E21-21

IBC: TABLE 1006.3.3, TABLE 1006.3.4(1), TABLE 1006.3.4(2) [IFC:[BE] TABLE 1006.3.3, TABLE 1006.3.4(1), TABLE 1006.3.4(2)]

Proponents: Mike Nugent, Chair, representing ICC Building Code Action Committee (bcac@iccsafe.org)

2021 International Building Code

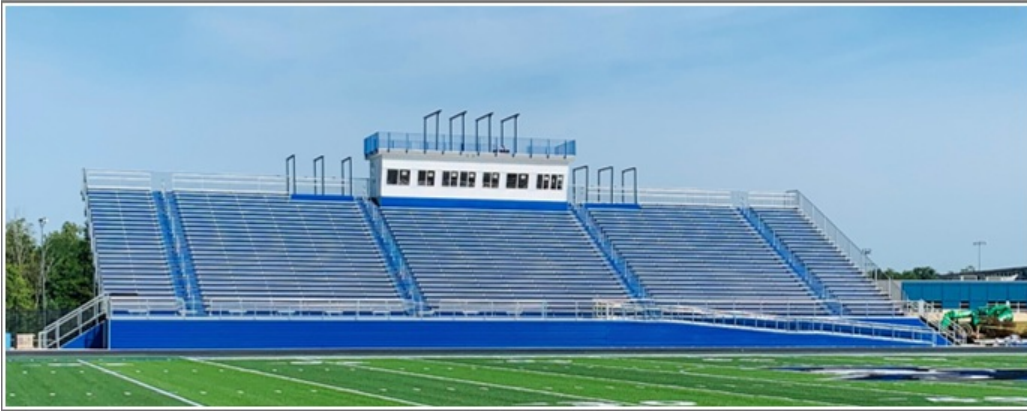
Reason Statement: The intent of this proposal is to emphasize an existing requirement for accessible ways out of assembly spaces. Assemble seating is required to have at least one accessible route into a space. Wheelchair spaces have to be provided, integrated and dispersed. In space with 50 or more occupants, at least two accessible means of egress are required. Section 1009.1 allows for persons with mobility devices to return back the way out the along the same route they used to get to their seats up so the length of the common path of travel. This provides for an equivalent level of safety for everyone in the assembly seating.

This can apply to spaces such as theaters, stadiums, bleachers, grandstands and folding and telescopic seating. Where this is currently being missed the most in is raised bleacher seating. The designers provide one ramp to get in, but commonly only have one steps on the other ends of the bleachers. Very often, this common path of travel could be met by one ramp the ends at the center of the bleachers.

Figure 1

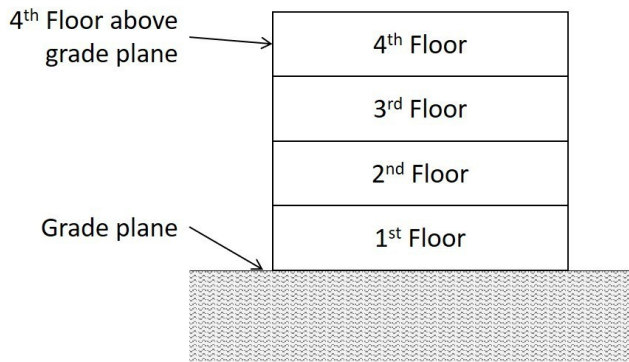
At one time, the two sections were nearly identical in their requirements. But then, the definition of "level of exit discharge" was revised from the "horizontal plane" where exit discharge begins to the "story" where exit discharge begins. Now these two sections are no longer in sync. The current code requirements are depicted in the figures below.

Section 3002.4 requires the elevator to accommodate a gurney in this building

The intent of this code change is to correlate the two requirements once again. Since previous editions contained wording for Section 1009.2.1 which required an elevator at the same floor level as Figure 2, it makes sense to revise the wording to revert back to this requirement.

Exception for occupied roof on a building with a horizontal exit.

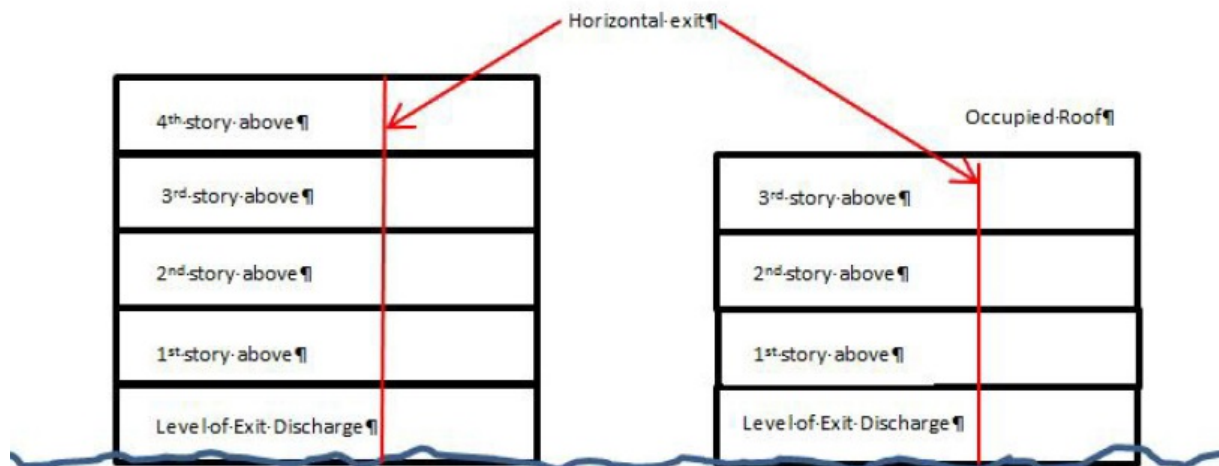
The new Exception 3 is to allow for buildings that have horizontal exits on all floors below and occupied roof, to not have elevators are part of the accessible means of egress (and then have to add standby power to the elevator) just because there is an occupied roof area. Roofs technically cannot provide horizontal exits because then cannot be subdivided with fire barriers. The purpose of horizontal exits are to provide refuge areas on the floor for protection of occupants from smoke. By being open to the outside air, the occupant on the roof are also protected from smoke.

It is important to note that the purpose of the standby power to the roof is for fire department assisted rescue – not self evacuation. Since the building occupants may not know where the fire is in the building, using the elevator on their own could result in them delivering themselves to the fire location. The fire department could choose to use the elevators for assisted evacuation in any building under fire department recall, so this option is still open. And in a building with horizontal exits, the fire department also has the option to temporarily relocate occupants who cannot use stairways

on the occupied roof to a safe area on the floor below rather than needing to transport them all the way out of the building immediately. The following is a diagram for illustration of this exception.

Transfer shower

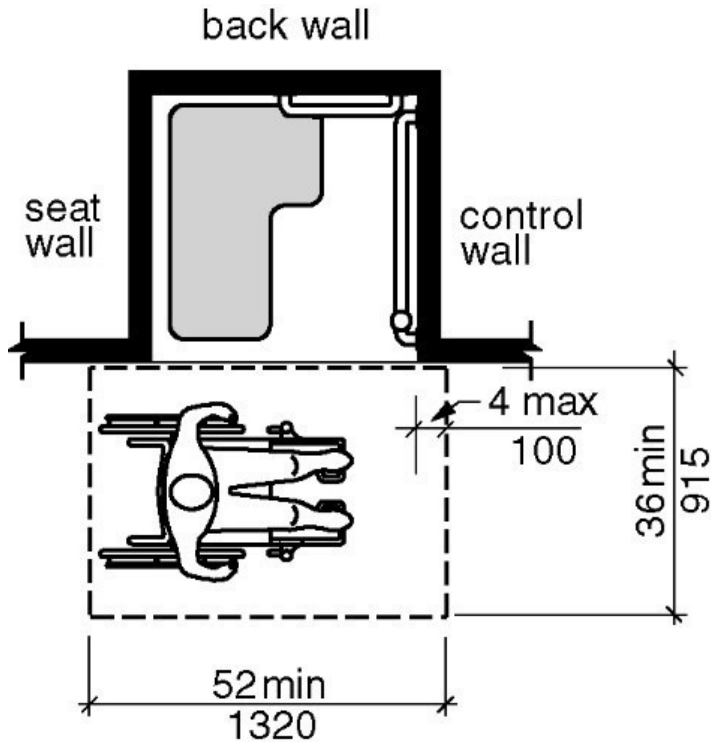
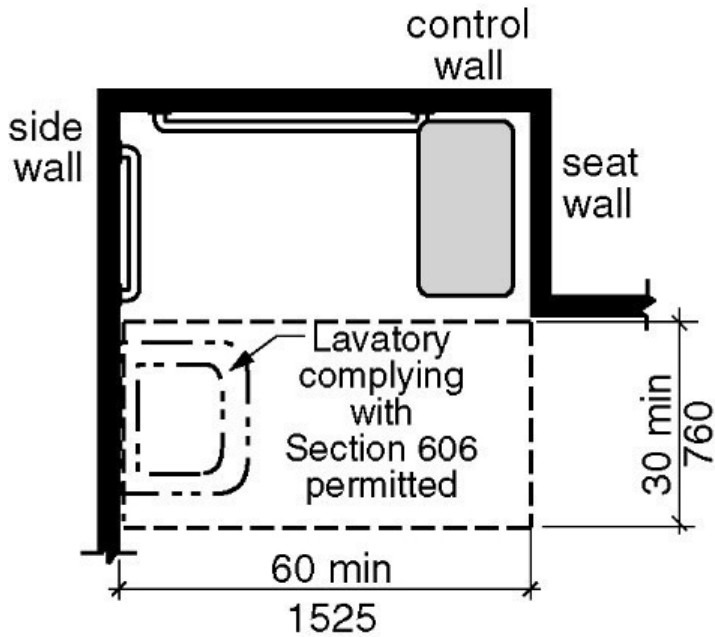
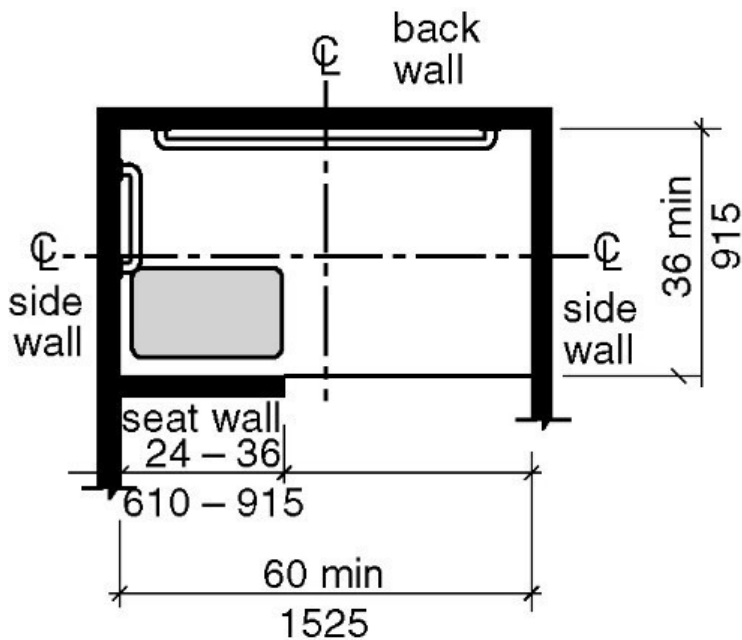
Reason Statement: If a hotel has all showers, Table 1107.6.1.1 could be read to force bathtubs in Accessible rooms. What is the reasoning/justification for this? A roll-in shower with a seat is doing double duty as transfer and roll-in. The table was written originally with the intent to require at least some roll-in showers when hotels typically provided all bathtubs. Designs for bathrooms have changed. Providing showers instead of tubs has been shown to reduce accidental falls in the bathrooms; while continuing to provide accessible options.

Figure 4005.2.3.6(1)
In-rack sprinkler layout for wooden barrels on their sides (plan view)

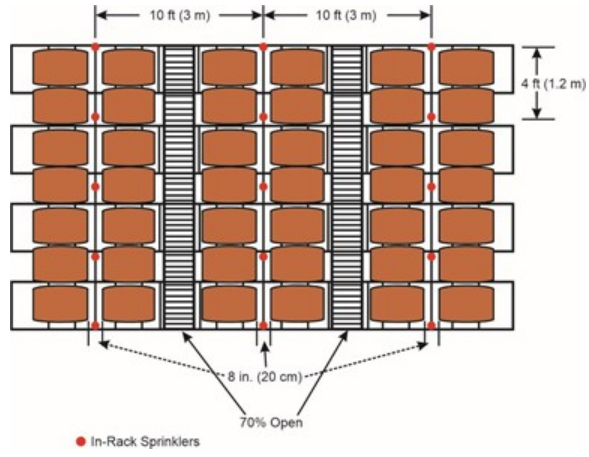
The fire sprinkler design criteria is core of this code change. Table 4005.1.4 provides criteria for sprinkler system densities, storage heights and sprinkler selection. This design criteria is based on full-scale fire testing conducted by FM Global and presented in FM Data Sheet 7-29.

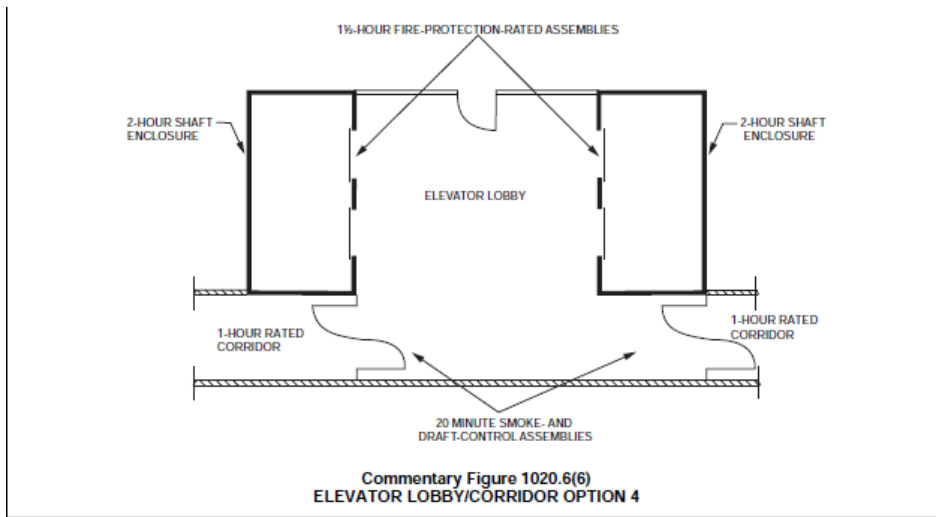
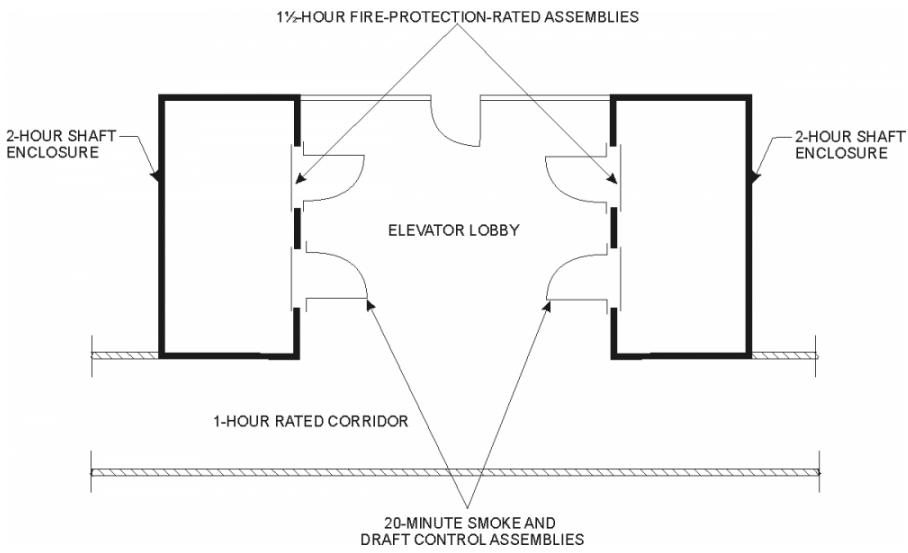
Reason Statement: The intent of this proposal is to allow for two and three story Group R and Group I-1 buildings that do not have to have elevator lobbies to not have smoke and draft control at the doors. Even with sprinklers, these buildings have fire resistance rated corridors. Elevators are within vertical shafts and are sent to fire barrier protection requirements in Section 712.1.1, 713.14 and 3002.1. Section 707.6 in fire barriers references Section 716 for opening protection of all openings, which would include door through the shaft to allows entrance into the elevator car. Elevator car doors often open directly into a rated corridor, so Section 716.2.2.1 is applicable to those elevator doors.

The new exception 5 in Section 716.2.2.1 is to allow for elevators in low rise building to not to have to meet the smoke and draft requirements of opening protectives in corridors. While many elevator hoistway/vertical shaft doors are tested and labeled for the 1-hour or 1 1/2-hour fire resistance rating (see Section 716.2.1), very few, if any of the doors typically sold in the United States will also meet the smoke and draft requirements (see Section 716.2.2.1.1) that would allow them to open directly into a fire-resistance-rated corridor.

802.1 General. Wheelchair spaces and wheelchair space locations in assembly areas with spectator seating shall comply with Section 802.

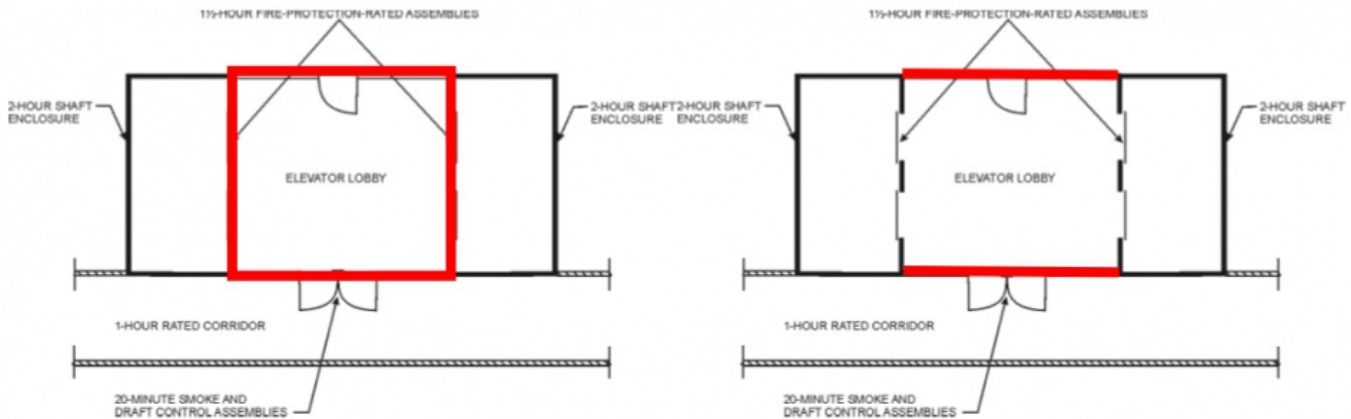
Reason Statement: The intent of this proposal is to clarify lobby protection requirements – which walls are fire barriers, fire partitions or smoke barriers. This will also clarify what requirements are applicable for the elevator hoistway doors vs. the doors in the other walls of the lobby protection. The current language is inconsistent for the locations where elevator lobbies are specified. This protection of elevator lobbies is a combination of the elevator hoistway and exit stairway (direct access to a stairway is required for fire service an occupant evacuation elevator lobbies) shaft enclosure/fire barriers and the fire partitions or smoke barriers required for lobbies (405.4.3, 3006.3, 3007.6.2 and 3008.6.2) The intent of new 708.4.1 and revised 709.4.2 is to clarify that the fire partitions/smoke barrier criteria is not applicable to all the walls of the elevator lobby since the vertical shaft/fire barrier protections is adequate. Fires typically happen in the occupied portions of the buildings, not within the elevator shaft or the stairway. In addition, in situations where an elevator lobby is provided, the elevator shafts are double protected from smoke intrusion from a fire on the floor.

**FIGURE 3115.8.3.4
CONTAINER ELEMENT IDENTIFICATION**

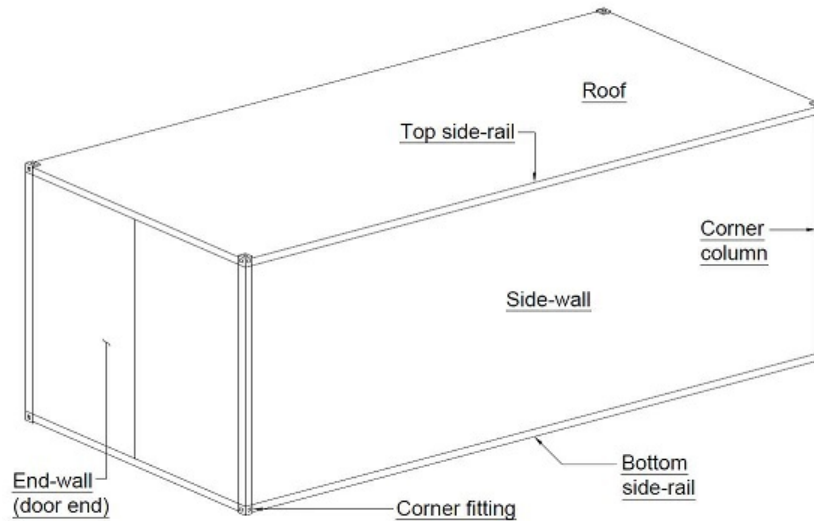
3115.8.3.4 Tested structural components. Where they are not altered, the structural components identified in Section 3115.8.3.4.1 and 3115.8.3.4.2 can be used with the load combinations of Section 1605.3 based on the testing performed during the *intermodal shipping container* certification process. This certification shall have been verified by the data plate and markings in Section 3115.3.

The components names are labeled in Figure 3115.8.3.4.
